Access Compliance Report

Public Rights-of-Way

(Curb Ramps)

Intersection ID: 13010	Main Street: HICKORY GROVE RD	Cross Street: DOGWOOD PL	Location: NE
ADA ID: BF179E1BF5D3	Ramp Type: PerpDiag	Initial Pass/Fail: Fail	Overall Compliance: No
Severity Score: 21.25			
Codes/Mitigation Info/Possible Solution		Field Measurements/Component Compliance

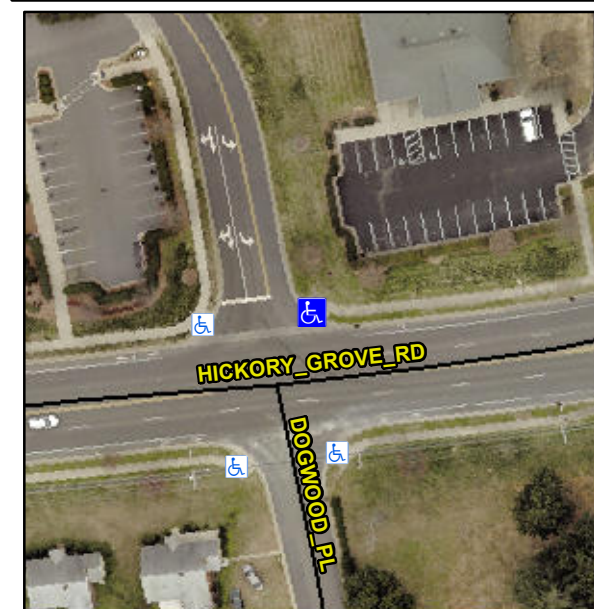
Possible Solutions:

Remove & Replace Curb Ramp With Two New Directional Ramps or Equivalent.

PROW/ADA:

Not Found, R304.5.1, R304.2.2

Compliance	Description	Data	Compliance	Description	Data
N/A	Ramp Length (in)	48.0	No	Ramp Slope (%)	10.0
No	Ramp Width (in)	45.0	Yes	Ramp XSlope (%)	1.7
N/A	Flare Type LT	N/A	N/A	Flare Type RT	N/A
N/A	Flare Slope LT (%)	N/A	N/A	Flare Slope RT (%)	N/A
N/A	Flare Traversable LT?	N/A	N/A	Flare Traversable RT?	N/A
N/A	Landing Length (in)	N/A	N/A	DWS Provided?	N/A
N/A	Landing Width (in)	N/A	N/A	DWS Contrast?	N/A
N/A	Landing Slope (%)	N/A	N/A	DWS Length (in)	N/A
N/A	Landing X Slope (%)	N/A	N/A	DWS Full Width?	N/A
N/A	Landing Curb? (Y/N)	N/A	N/A	DWS Offset (in)	N/A
N/A	Shared Landing?	N/A			
N/A	Gutter Ponding?	N/A	N/A	Gutter Slope (%)	N/A
N/A	Gutter Lip Ht (in)	N/A	N/A	Gutter X Slope (%)	N/A
N/A	Painted X Walk1?	No	N/A	Painted X Walk2?	No
	X Walk 1 Direction	To W		X Walk 2 Direction	To S
N/A	X Walk 1 Width (in)	N/A	N/A	X Walk 2 Width (in)	N/A
	X Walk 1 Slope (%)	2.3		X Walk 2 Slope (%)	4.3
	X Walk 1 X Slope (%)	1.2		X Walk 2 X Slope (%)	0.5
